**COMMONWEALTH OF KENTUCKY
BEFORE THE KENTUCKY STATE BOARD
ON ELECTRIC GENERATION AND TRANSMISSION SITING**

**In the Matter of the Application of Glover Creek Solar,)
LLC, for a Construction Certificate to Construct a) Case No. 2020-00043
Merchant Electric Generating Facility)**

MOTION TO AMEND PROJECT BOUNDARIES

Exhibit A

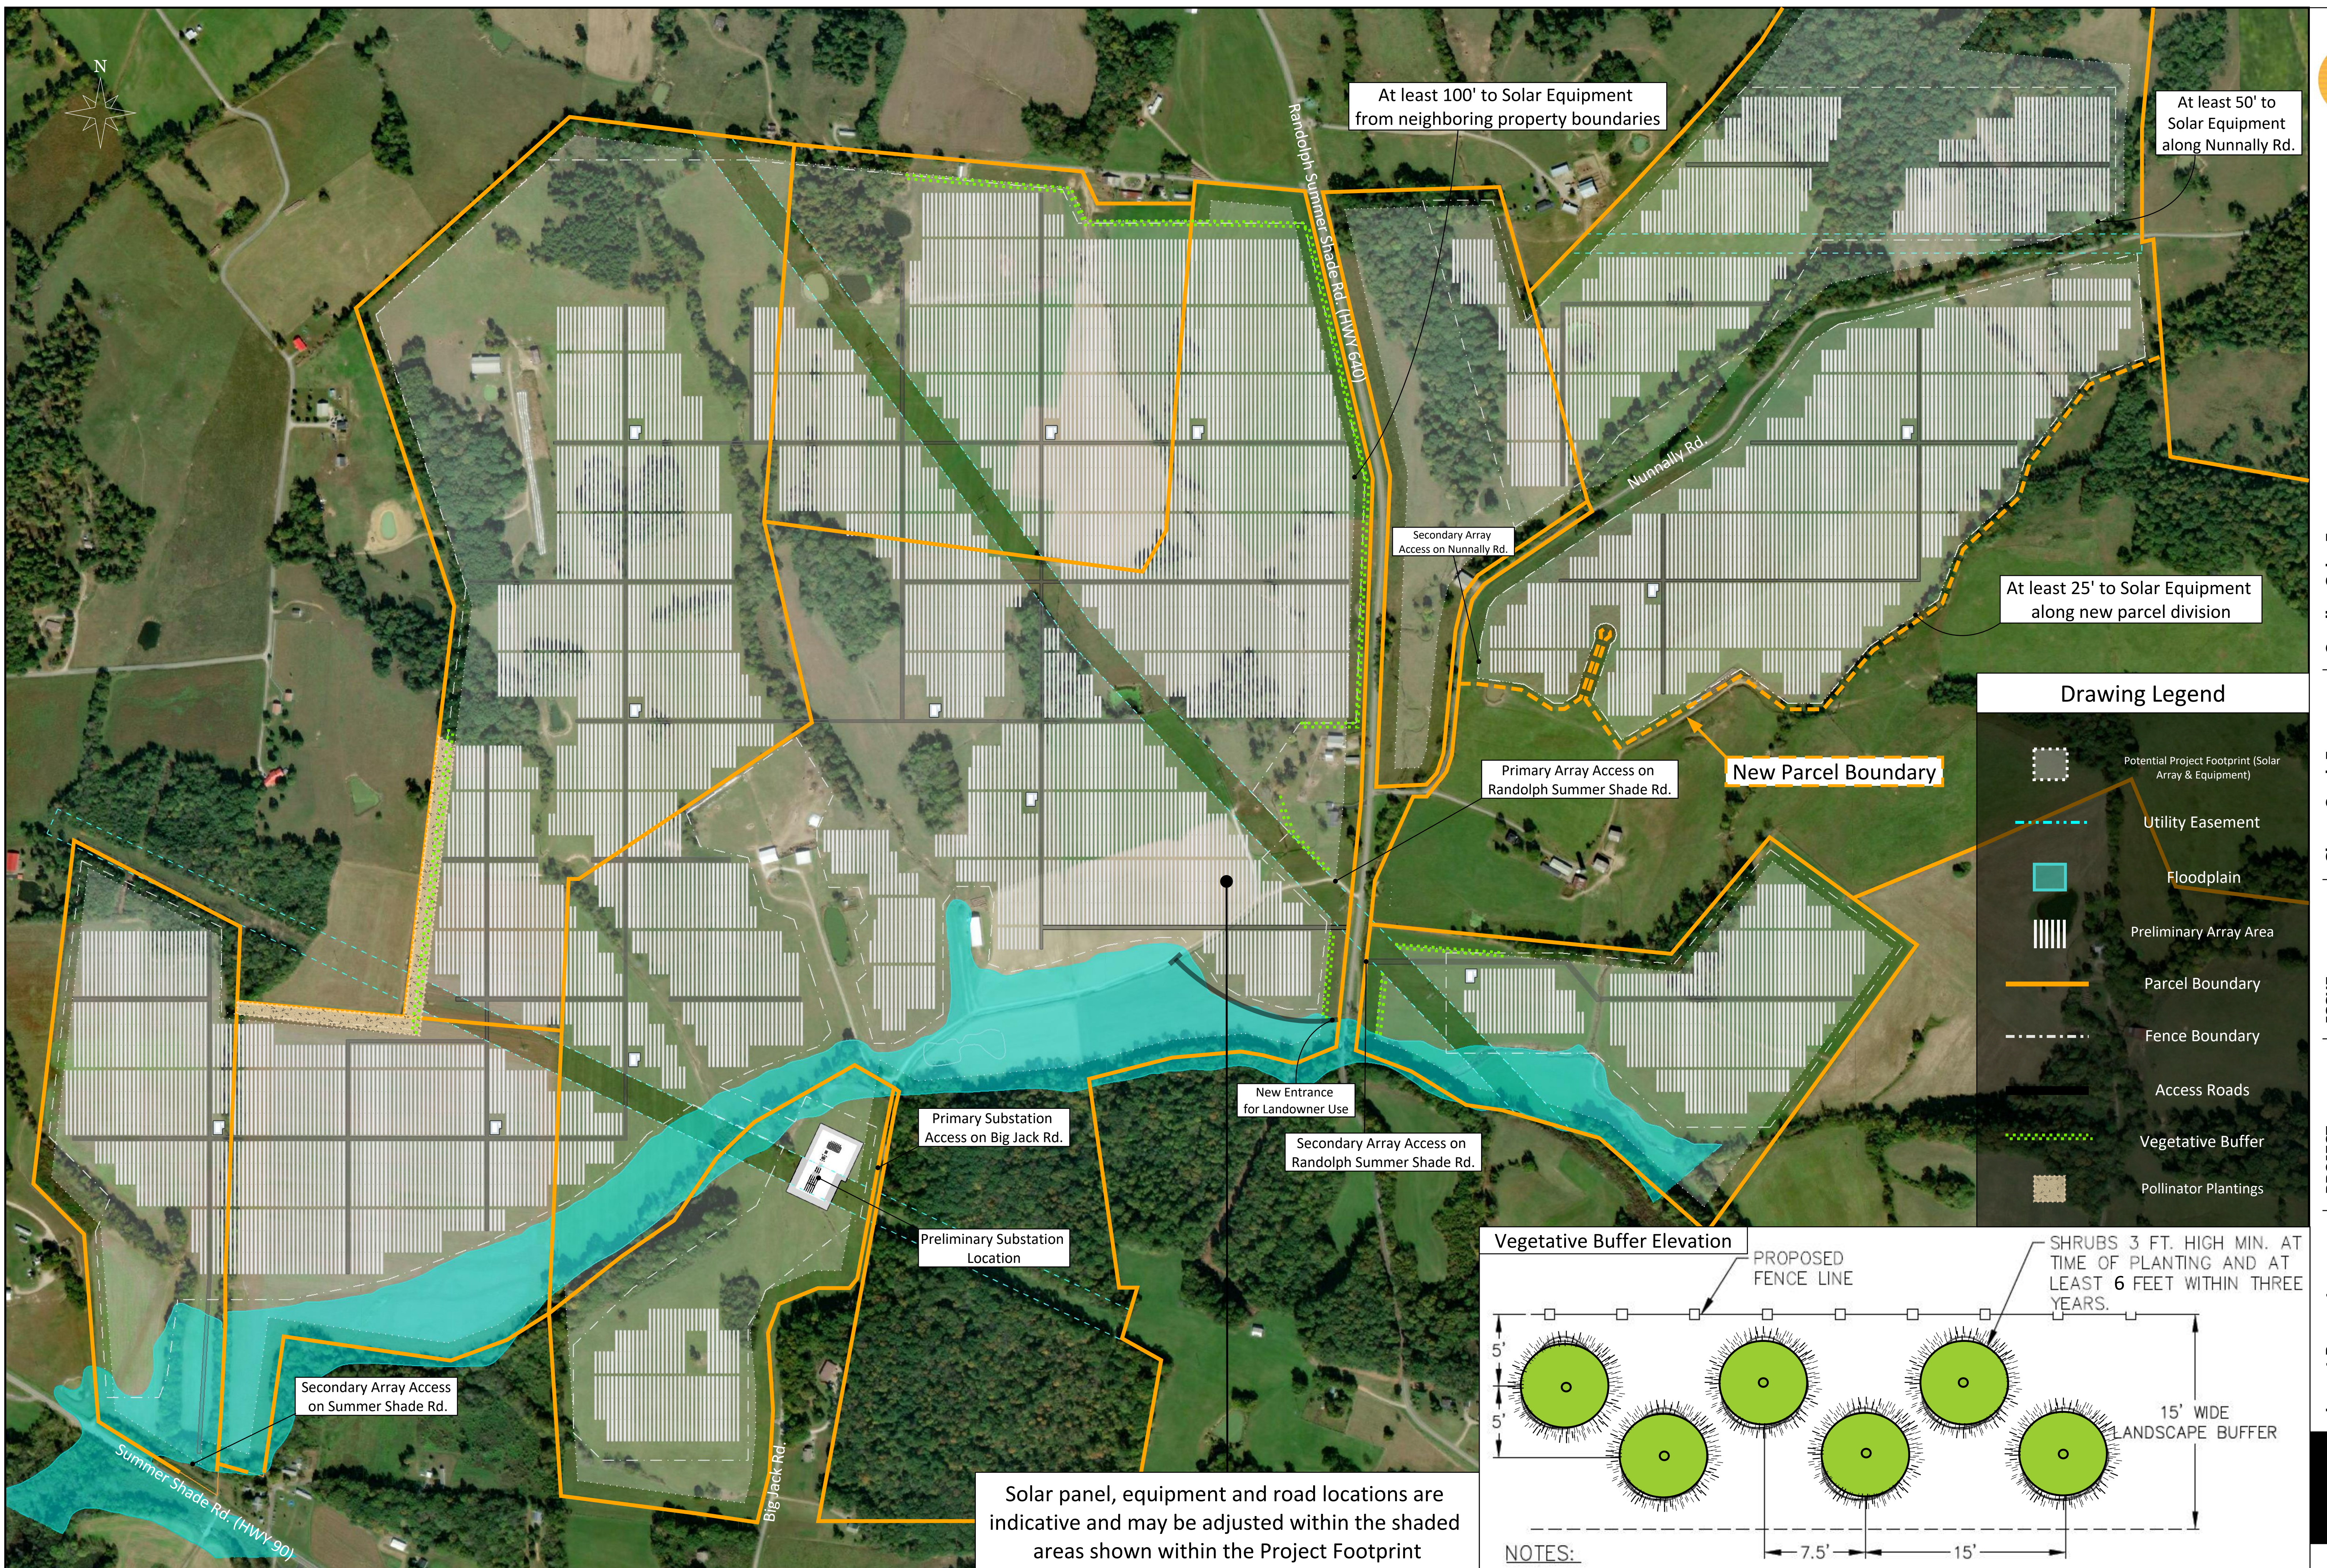
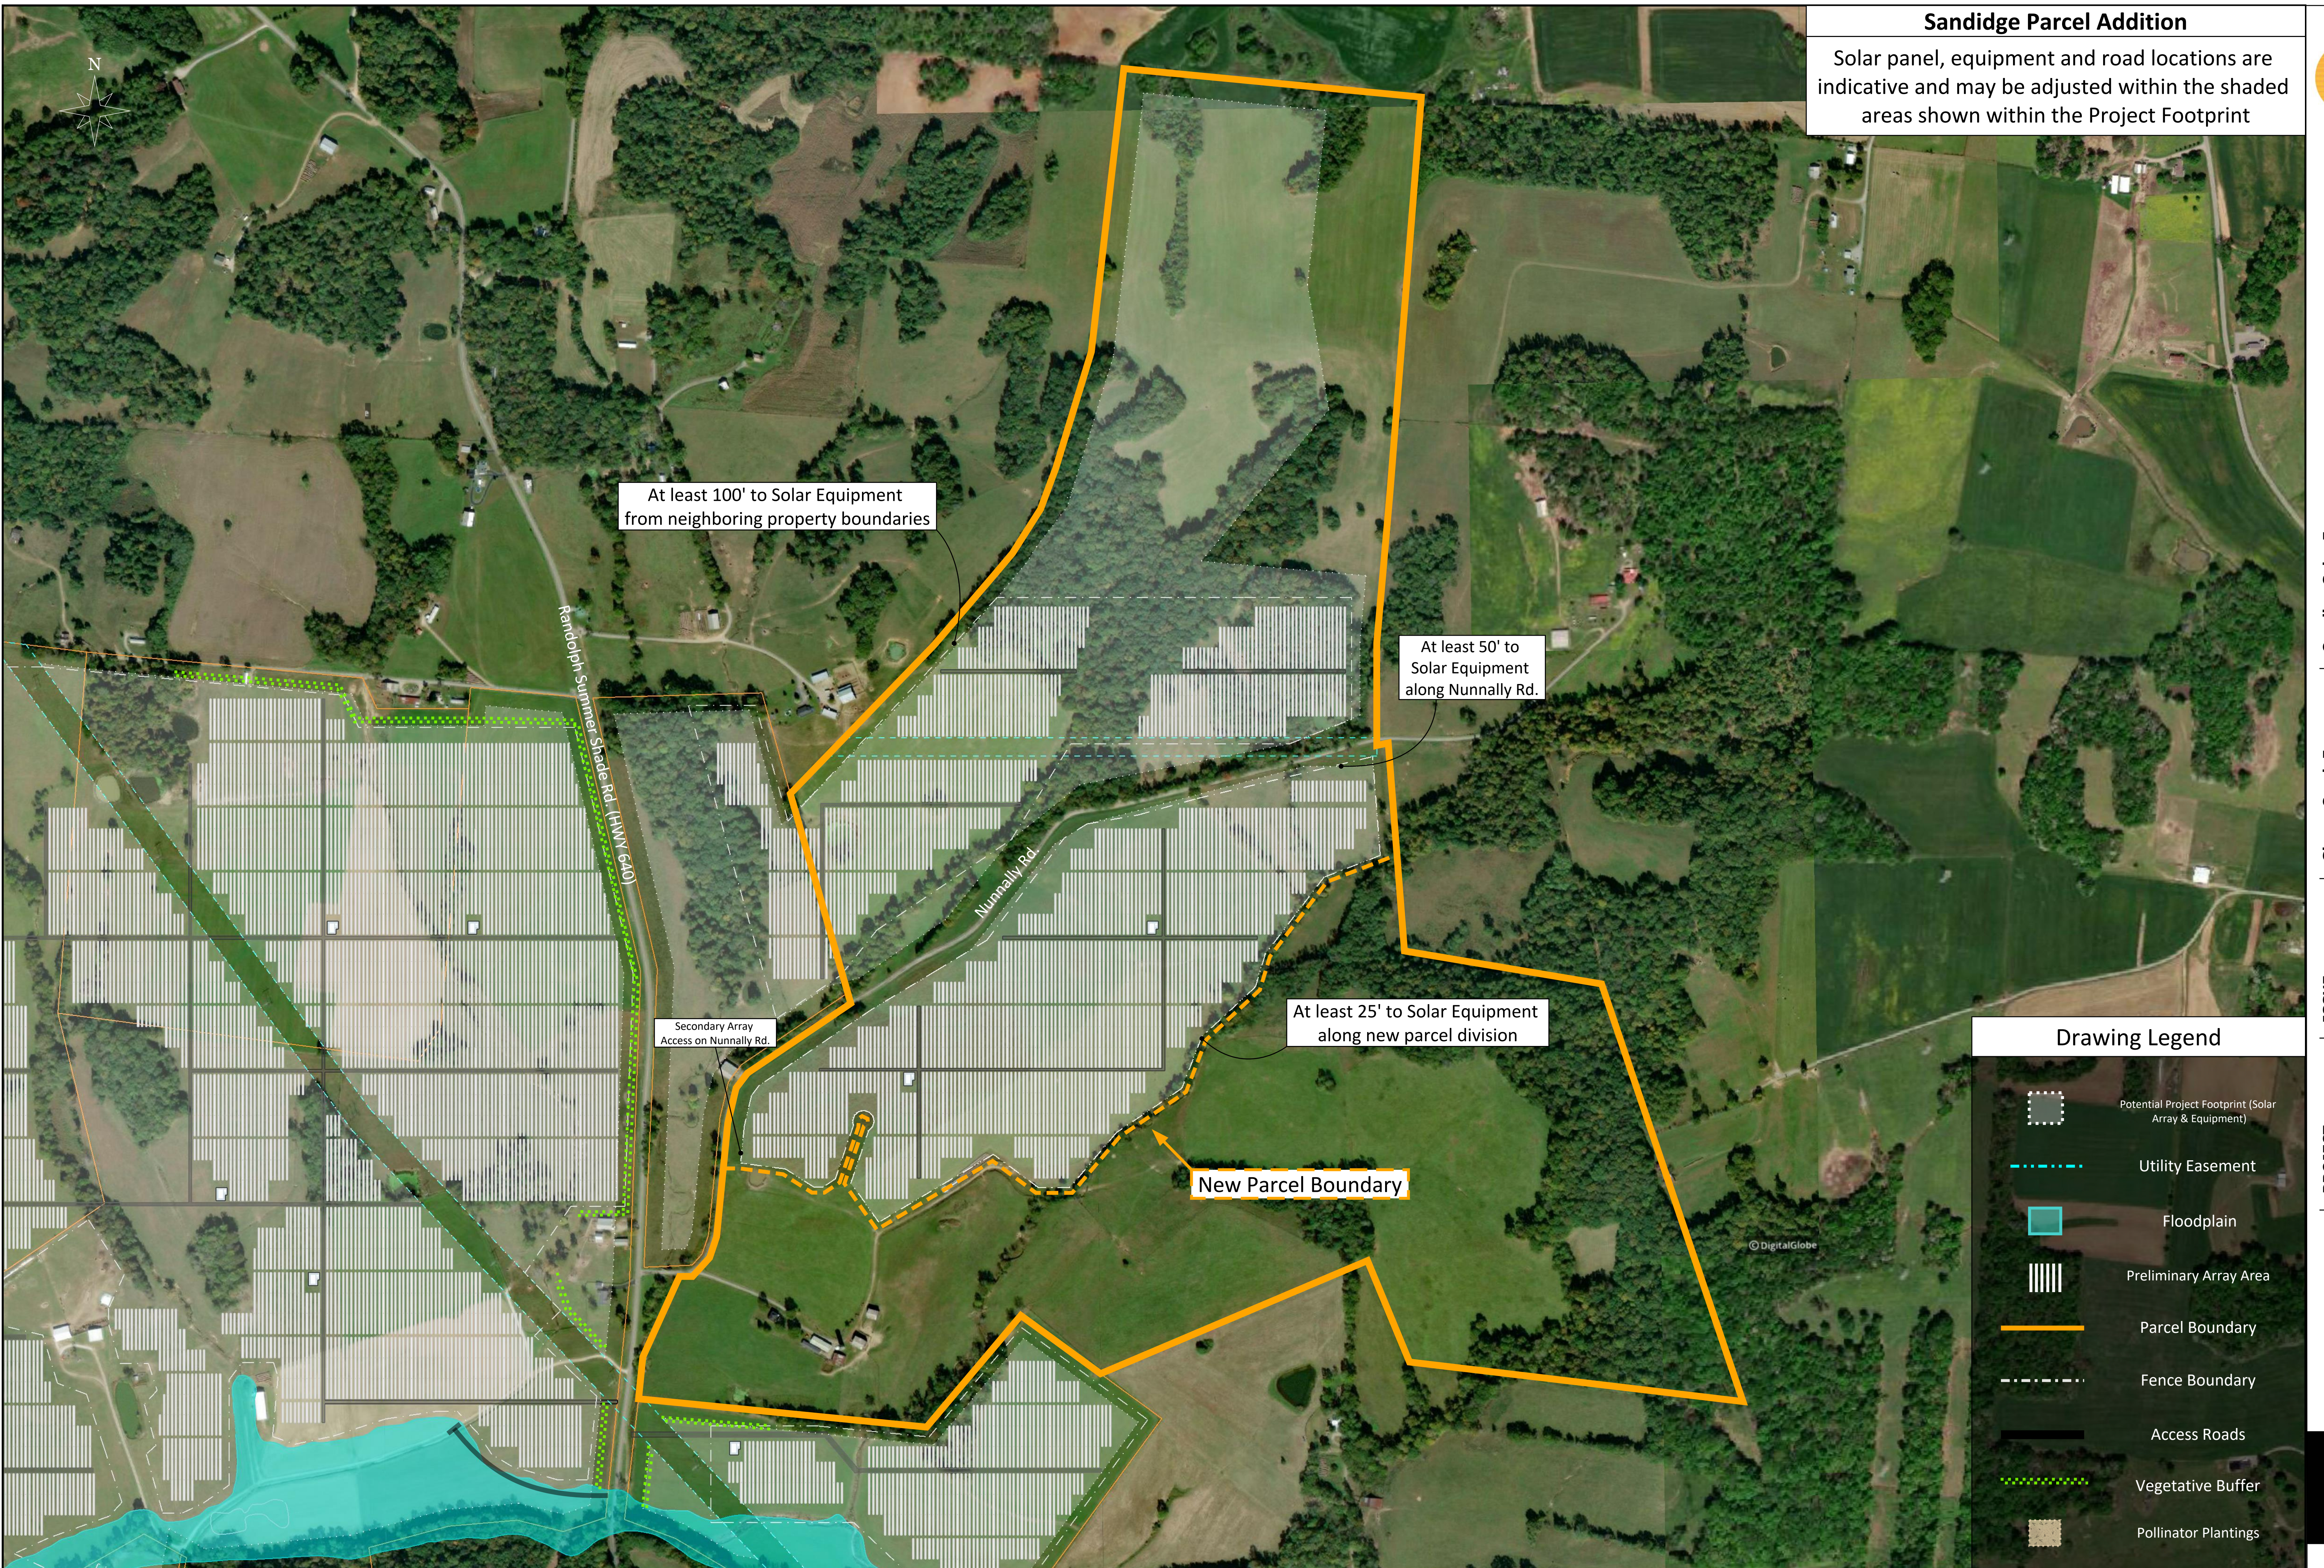
Glover Creek seeks to incorporate approximately 160 additional acres to its Project area. This additional property (the “Sandidge” property or parcel) is located generally on the northeast side of the Project, as depicted on the revised site plan attached as Exhibit A.

STATUS: The revised site development plan is attached hereto as Exhibit A. There are no material changes to the original site plan area that the Siting Board reviewed previously.² The original Project area, setbacks, entrance locations, and substation location on the original Project area all have not changed.

The revised site development plan at Page 1 shows the original Project area, together with the portion of the Sandidge parcel that is most likely to be used for the Project. Solar panels, inverter and energy storage locations, and interior access road locations are indicative, and will change in the final design process. The new parcel boundary that will be created when the Sandidge parcel is subdivided prior to the Project's purchase of the Sandidge property is shown with a dotted orange line, and labeled "new parcel boundary." The Sandidge property subdivision has not yet occurred, and will occur at the same time that Glover Creek closes on the land purchase with the Sandidges.

The revised site development plan at Page 2 highlights the existing Sandidge parcel boundaries. The area shown as the "Potential Project Footprint", highlighted with a light grey color

and outlined with a white dashed line, depicts all of the land that may be used for the Project. The Northern portion of the Sandidge parcel is likely to be excluded from the final site design, but is included within the Potential Project Footprint because it may be needed for the Project in order to ensure there is enough land for the Project. Any portion of the Potential Project Footprint area that is not needed for the Project will be left out of the final site plan that will be provided to the Siting Board prior to construction. Only land that is included within the Potential Project Footprint will be used for the Project; Glover Creek proposes that the Project's footprint area may be reduced from the Potential Project Footprint area shown on Exhibit A, but not increased.

The site plan in the original application proposed one hundred (100) foot setbacks around the property boundary, and Applicant does not wish to change that portion of the original application. Due to the constrained amount of land available, however, Applicant proposes the following setbacks only for the Sandidge property portion of the site layout, as shown on Exhibit A, as follows:

- 25 feet from the New Parcel Boundary as marked on Exhibit A
 - 50 feet from the Nunnally Road right of way
 - 100 feet from non-participating adjoining parcels
1. A list of the surrounding parcels and land uses is identified in the letter from Kirkland Appraisals, LLC, and attached as Exhibit G. Page 3 of the Kirkland letter lists the adjoining parcels, states whether each parcel has a residential home, and states the minimum number of feet between the nearest residential home and solar equipment. This minimum distance is 150 feet.
 2. Exhibit H contains the boundary survey and legal description of the Sandidge parcel. The survey and legal description depict the portion of the Sandidge parcel that will be

At least 100' to Solar Equipment from neighboring property boundaries

At least 50' to Solar Equipment along Nunnally Rd.

At least 25' to Solar Equipment along new parcel division
